Flight Procedures Cover Page	Task Action: P-NOTAM	Task Type: IAP	Estimated Chart Date: 01/27/2022	APWS Task ID: 1D0F4C88F1F243A4B56A2CEDFB5C670F	APWS Project ID: 0C3CE7CAED5E4233A1BD9B91E4456B3C
Procedure: LOC RWY 25 AMDT 12C		Enroute: NO	Specialist: Cappabianco, Anthony		Agreement Number:
Airport ID: KHHR			Airport City: HAWTHORNE		State: CA
Facility ID: HHR	Facility Type: LOC	Flight Inspection Remark Type:			
<p><b>Procedure Comments:</b>          CLEARS FDC NOTAM 1/7562.</p> <p>PROCESSED IAW TECHNICAL SUPPORT GROUP (AJF-17) MEMO DATED 07/07/2021, SUBJECT: GUIDANCE FOR PROCEDURAL CHANGES REQUIRING FLIGHT INSPECTION/VALIDATION.</p> <p>CONTACT CASIMIR TABAKA 405-954-7931.</p>

LOC Rwy 25  
Jack Northrop Field/Hawthorne Muni (HHR)  
Hawthorne, CA

**Procedure Name(s):** RNAV (GPS) Rwy 25 Amdt 3 LOC Rwy 25 Amdt 13 VOR Rwy 25 Amdt 17

**OLD****LOC RWY 25**

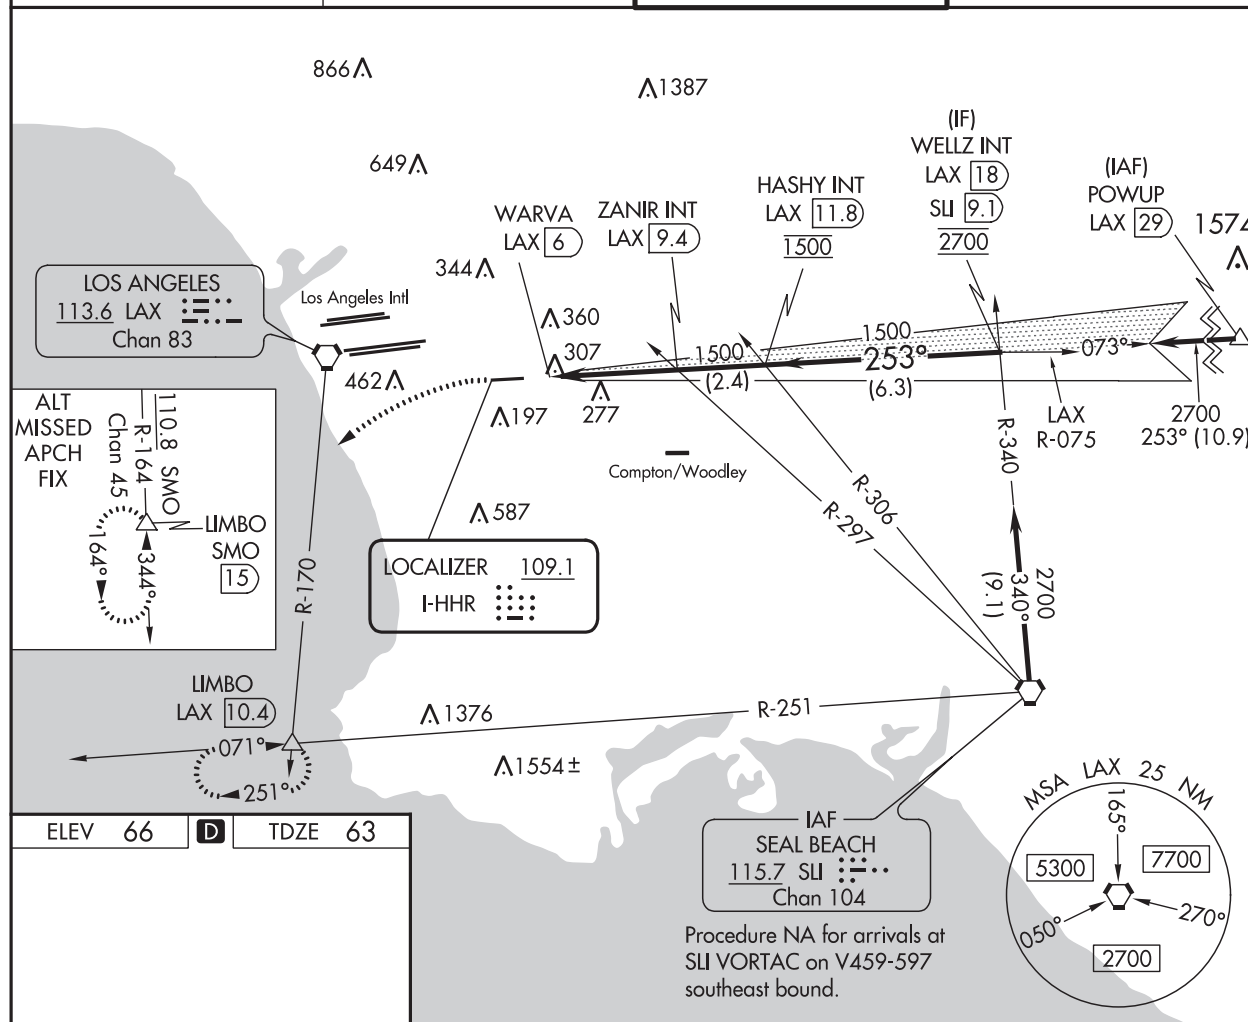
The Federal Aviation Administration is proposing to remove the note "Procedure NA at night" from the following instrument approach procedures serving Jack Northrop Field/Hawthorne Municipal Airport

The proposed action is the culmination of an extended effort to restore night minimums for the airport. The appropriate waivers have been approved and a NOTAM has been issued restoring night operations.
